Re: Blackhawk Mine N.O.V. #N81-2-2-1 ACT/043/001

Basin Number SILT BASIN "C"

UTAH COAL AND ENERGY
 BLACK HAWK MINE
 DRAINAGE AREA FOR
 SILT BASIN "C"

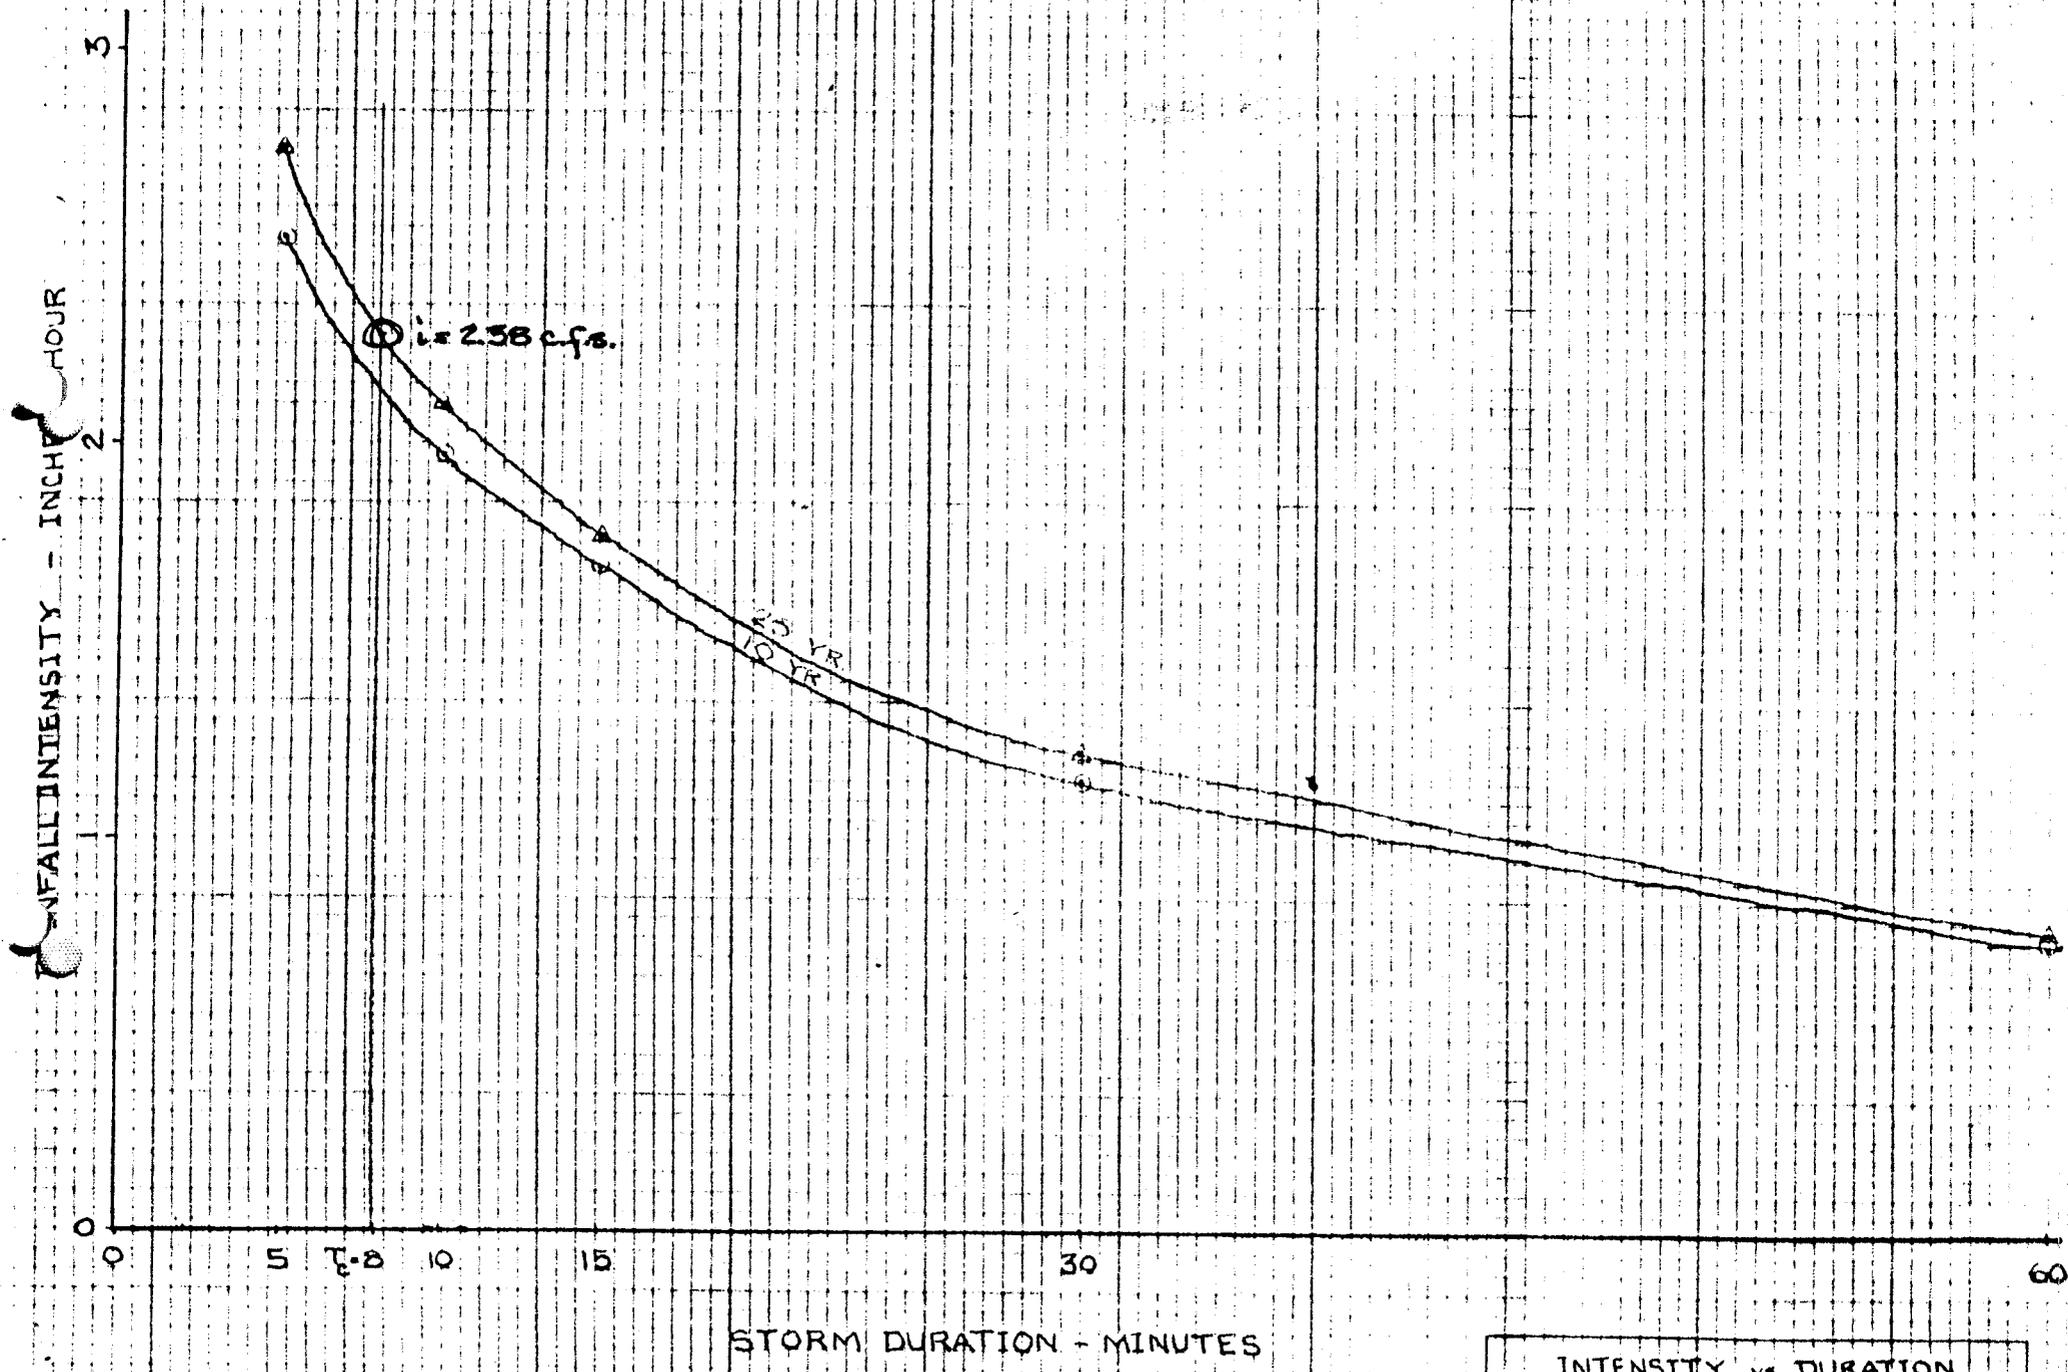
- also drain area a mix of dist + undist. runoff?
- what are dotted lines for? on map
- ^{are those} diversions running N-S on W side
Shop + tipple?
